## Cumnor Parish Council - Plan Receiver - [P24/V2480/FUL](#)

<b>Date Reviewed:</b>	10/12/2024 and 13/02/2025
<b>Version:</b>	V2
<b>Application Reference:</b>	<a href="#">P24/V2480/FUL</a> as amended 3 <sup>rd</sup> February 2025
<b>Application Type:</b>	Full
<b>Amended Proposal Description:</b>	Subdivision of land to rear and erection of 4 bedroom 2 storey dwelling and 1.5 storey detached garage. Use of new access to Cumnor Hill allowed by application P23/V1945/HH. Provision of fire appliance turning space, associated landscaping and bin store.
<b>Address:</b>	96 Cumnor Hill Oxford OX2 9HY

**Cumnor Parish Council  
17<sup>th</sup> February 2025**

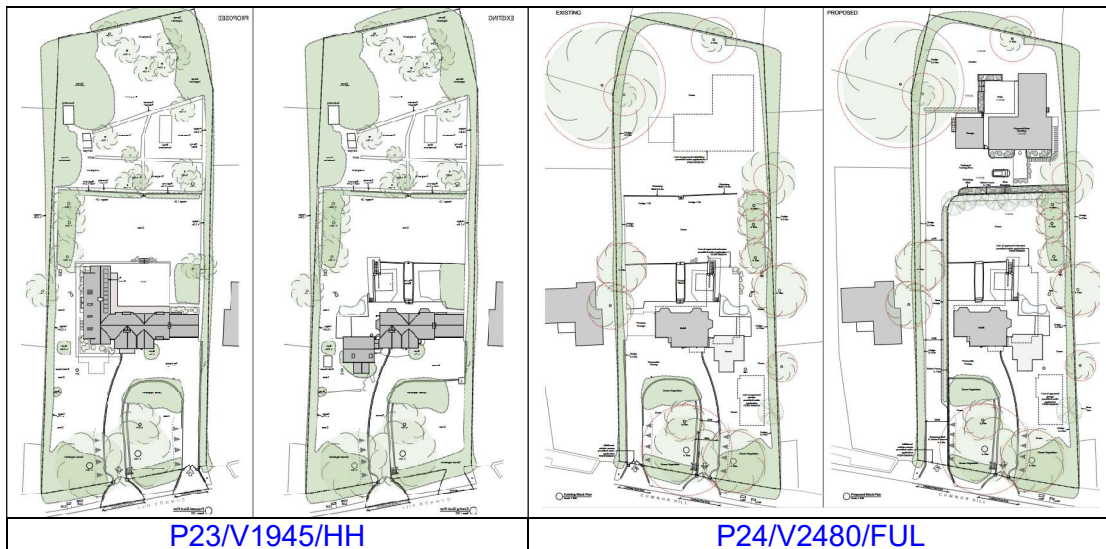
However, the accompanying Tree Survey Report and Google Earth Pro concur, showing an elevation change of at least 4m across the site (117+m in front garden of #96 to 113m in back garden of proposed backland dwelling with a further 3m drop to the eastern wall of 5 Hids Copse Road (see section below).

Interestingly, 5 Hids Cope Road is stated in the application to be 22m distant from the proposed 10.5m high new property, just 1m over the 21m 'overlooking' requirement.
